Parts Change Information

SUBJECT → TR/CR Drum Rear Frame & Actuator Plate

APPLIES TO: **TR, CR** | **DOCUMENT NO: 20387**

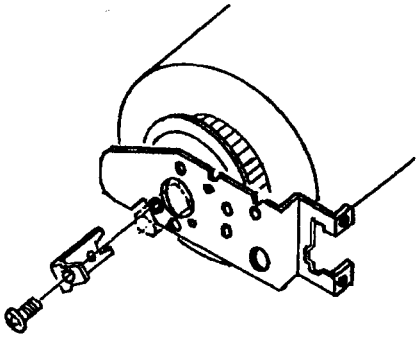
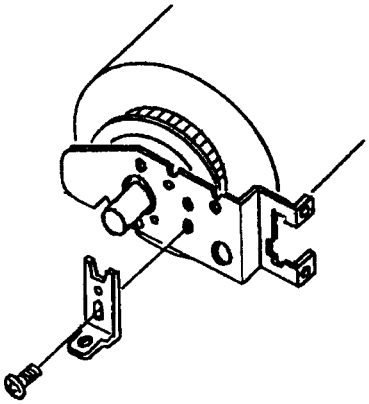
Procedure: Make sure to move the drum safety switch actuator plate from its shipping position to its normal printing position during machine installation.

During Shipment

During Normal Operation
